## SAN FRANCISCO PUBLIC UTILITIES COMMISSION

**Subject: Response to Comments on the Section 404(b)(1) Alternatives Analysis for the Calaveras Dam Replacement Project, Alameda and Santa Clara Counties, California**

Thank you for your letter of February 24, 2010, providing comments on the December 2009 Clean Water Act (CWA) Section 404(b)(1) Alternatives Analysis for the Calaveras Dam Replacement Project. This letter provides specific responses to each of your comments.

**FINAL  
PROJECT COMPONENTS**

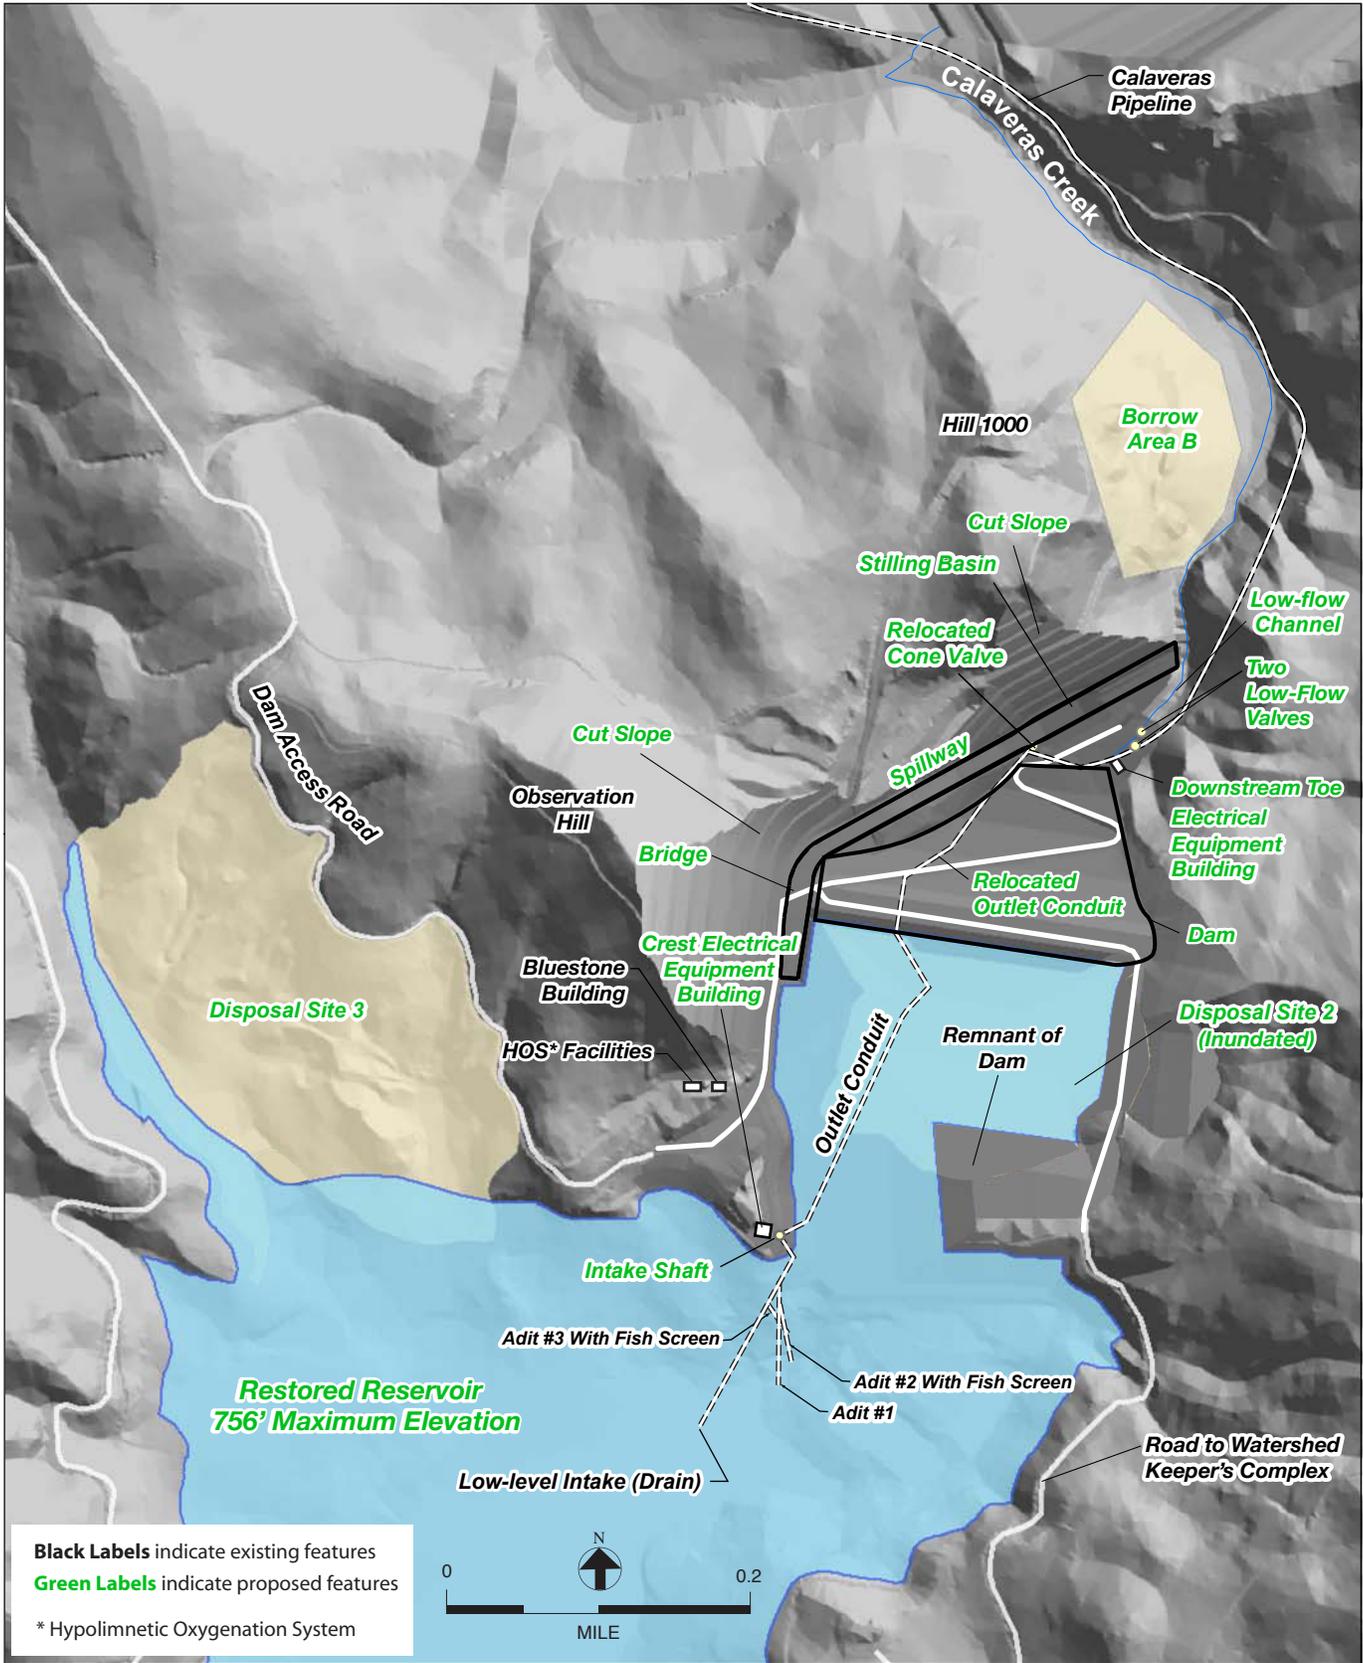
### **Comment 1: Staging Areas**

The Proposed Project includes 11 staging areas with a combined total area of approximately 35.4 acres. The staging areas are required for the contractor's and SFPUC's office trailers, an on-site soils testing laboratory, equipment and maintenance yards, construction materials storage, and for stockpiling imported filter, drain, and aggregate materials. During project design, efforts were made to locate the staging areas to avoid or minimize impacts to jurisdictional features. With the exception of Staging Area 1, none of the staging areas would directly impact a jurisdictional wetland or other water.

Staging Area 1 is located at the intersection of the dam access road and Calaveras Road. The dimensions and layout of this staging area are the minimum area that would accommodate imported filter, drain, and aggregate materials. Staging Area 1 is the largest of the 11 staging areas and is a critical component of the Proposed Project; eliminating it is infeasible, as there are no other large, potential staging areas nearby that would not have comparable or greater environmental impacts.

As initially configured, preparation of Staging Area 1 would have resulted in the discharge of fill material to two wetlands and a seasonal stream. However, in keeping with the Section 404(b)(1) requirements, the northern and western limits of this staging area were modified to avoid one of the wetlands, the seasonal stream, and a sensitive terrestrial habitat. Implementing the current design for the area would result in the discharge of 135 cubic yards of fill material to 0.08 acre of seasonal wetland.

The seasonal wetland that would be filled at Staging Area 1 is located approximately 200 feet from Calaveras Road, essentially in the core of the staging area. As indicated in the Alternatives Analysis and in the application before your agency for a Section 401 Water Quality Certification, the fill in the seasonal wetland at Staging Area 1 would be temporary. The SFPUC proposes to place a protective geotextile fabric over the wetland for the duration of the project. At the end of project construction, the fill would be removed and the site would be returned to its natural grade and the wetland restored to (at a minimum) its pre-project condition.
